UNITED STATES PATENT AND TRADEMARK OFFICE

APPLICATION NO.	FILING DATE	FIRST NAMED INVENTOR	ATTORNEY DOCKET NO.	CONFIRMATION NO.
10/809,336	03/26/2004	Cecilia DeVenezia	DV-04	9525
47728	7590	10/17/2005	EXAMINER	
THOMAS J. GERMINARIO, ESQ. 154 ROUTE 206 CHESTER, NJ 07930			HAWK, NOAH CHANDLER	
			ART UNIT	PAPER NUMBER
			3637

Office Action Summary

DETAILED ACTION

Jacinto et al. Figure 1

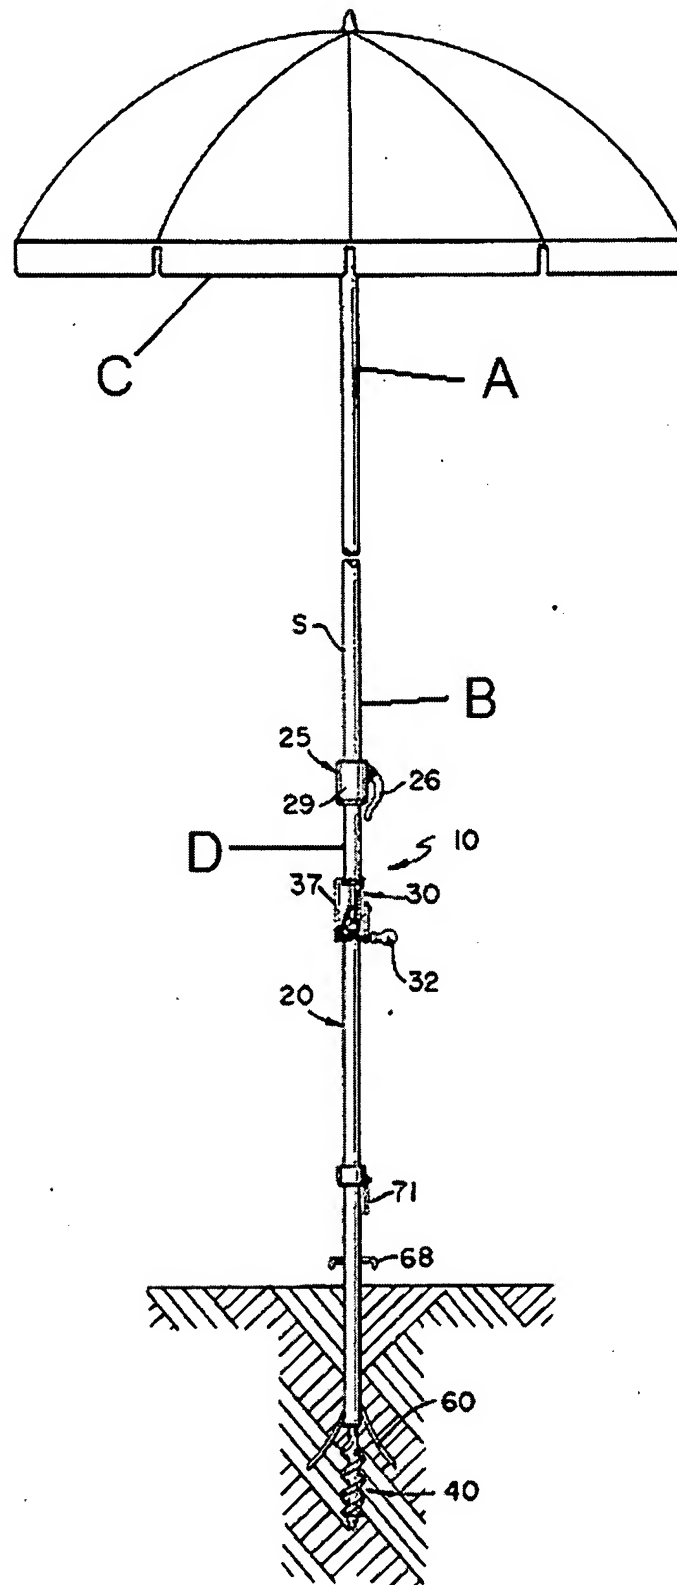
9. Claim 1 is rejected under 35 U.S.C. 103(a) as being unpatentable over Jacinto et al. in US Patent 5152495 in view of Doreste in US Patent 6267127. Jacinto et al. disclose a self-anchoring beach umbrella comprising a canopy member having an upper tubular element (A), to which a spreadable canopy (C) is attached, and a lower tubular element (B); a pole member (20) having an upper element (D), a motor element (137), comprising a reversible electric motor (80), having on its lower end an axially-disposed shaft (35) through which a rotary torque is generated when the motor is activated and an auger (40) coupled to the shaft of the reversible electric motor such that the auger

rotates in a forward or reverse direction when the motor is activated; a battery chamber (E) located in or mounted upon the pole member, said battery chamber having within it one or more batteries (90) and having a means (F) for accessing said batteries so that they may be removed and replaced or recharged; a switch (100) mounted on the motor element of the pole member and electrically connected to the batteries, whereby the motor may be activated and the direction and speed of the motor may be controlled.

Jacinto et al. do not teach an axial lumen in the lower tubular element or an upper element for insertion therein. Doreste teaches a beach umbrella device with a canopy member (12) having a lower tubular element (20) within which is formed an axial lumen (26) as well as a pole member (50) having an upper element (52) formed for insertion into the axial lumen of the canopy member. It would have been obvious to one of ordinary skill in the art at the time of invention to modify the device of Jacinto et al. by using an axial lumen in the lower tubular element to receive an upper element formed for insertion therein as taught by Doreste in order to allow the canopy member to be more easily separated from the pole member.

Campomar, Figure 3

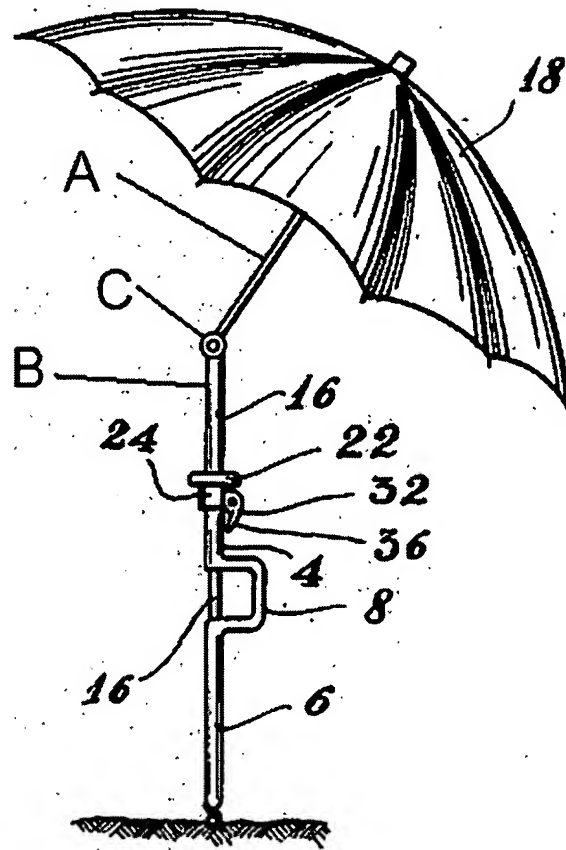
15. Claim 7 is rejected under 35 U.S.C. 103(a) as being unpatentable over Jacinto et al. in view of Doreste as applied to claim 1 above, and further in view of Campomar in US Patent 2628797. As stated above, Jacinto et al. in view of Doreste teaches all of the limitations of Claim 1 including an augur-anchored beach umbrella, but does not teach a tilting umbrella. Campomar teaches an auger-anchored umbrella with a joint means (C) disposed between the upper (A) and lower (B) tubular elements for tilting the upper tubular element of the canopy about an axis with respect to the lower tubular element. It would have been obvious to one of ordinary skill in the art at the time of invention to modify the device of Jacinto et al. in view of Doreste by using a tilting umbrella as taught by Campomar in order to change the position of the umbrella without changing the anchor position.
